## Technical product information

<b>Topic</b>	Continental Series and Flying Spur - Camshaft Timing Over Advanced - V8T
<b>Market area</b>	Bentley: worldwide (2WBE),China 796 VW Import Comp. Ltd (Vico), Beijing (6796)
<b>Brand</b>	Bentley
<b>Transaction No.</b>	2047762/5
<b>Level</b>	EH
<b>Status</b>	Released for publishing
<b>Release date</b>	May 18 2026

Figure 3

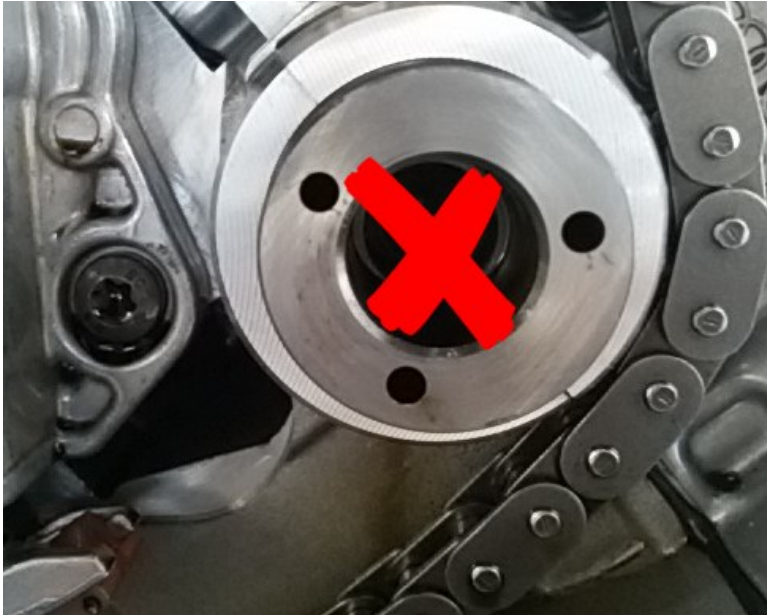
- When replacing the camshaft adjusters check and confirm the specification of ALL four camshaft mating faces IMPORTANT: Should the camshaft faces be smooth as shown in Figure 3 all four camshafts should be replaced
